CONSTRUCTION – PHASE 2

**NEW CENTER FOR EMERGENCY SERVICES
25 ROCKY HOLLOW ROAD
NORTH STONINGTON, CT 06359**

S/P+A PROJECT NO. 13.220

DATE: March 10, 2017

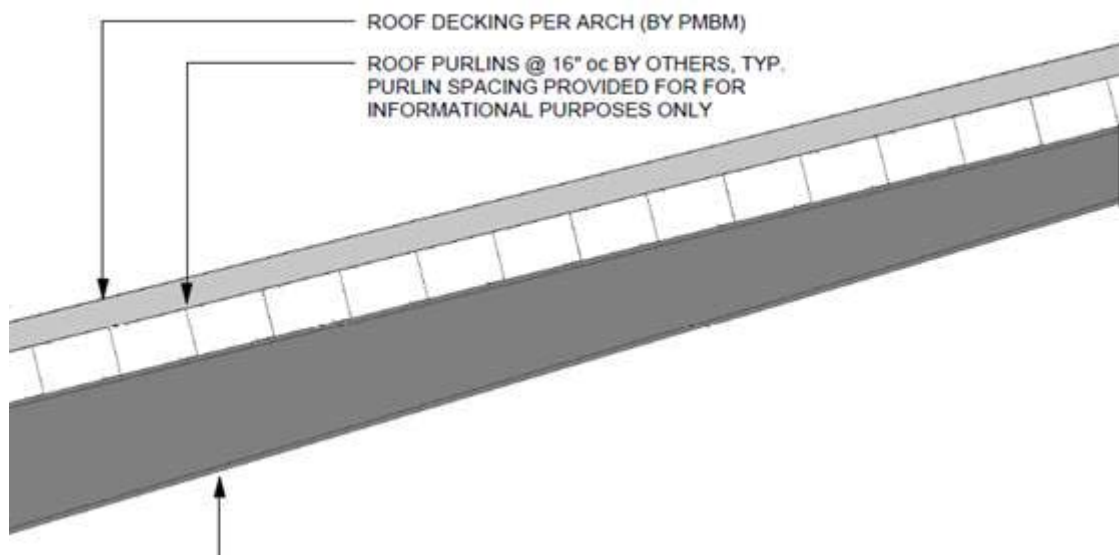
Dave,
 On drawing S200, there is a note Roof Purlins @ 16" oc by OTHERS. Please clarify who is referred to as "OTHERS" (Owner?)

Good afternoon Roel.
 Roof purlins are to be part of the PEMB.
 Thank you and good luck.

PA SYSTEM RISER DIAGRAM
NTS

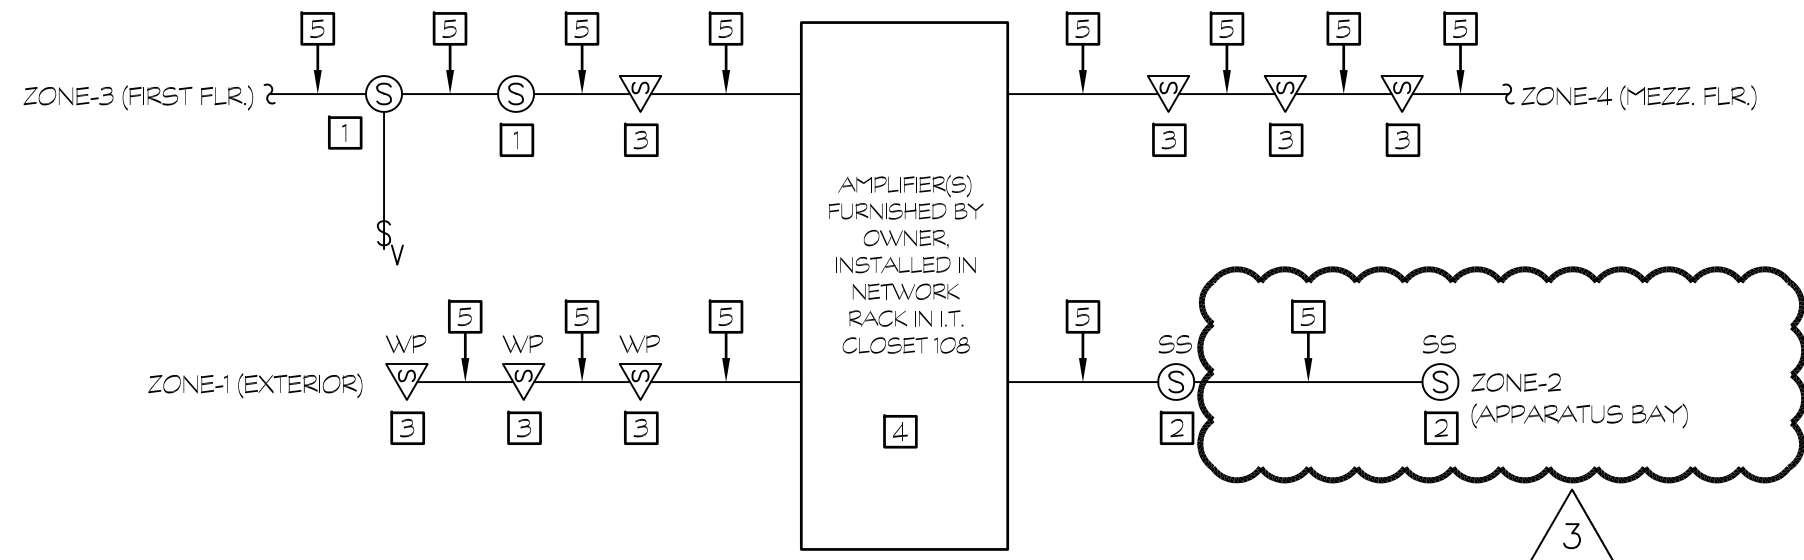
- The following ARCHITECTURAL sketch (1) has been added and is attached as part of this addendum.
 - SKA2A, WALL MOUNTED EXTERIOR SIGNAGE DETAIL. This sketch adds information to Drawing A4.0.
- The following TECHNOLOGY sketches (2) have been added and are attached as part of this addendum^.
 - SKT1, TECHNOLOGY SYMBOLS, NOTES & ABBREVIATIONS. This sketch revises information on Drawing T001.
 - SKT2, TECHNOLOGY ONE LINE DIAGRAM & DETAILS. This sketch revise information on Drawing T201.
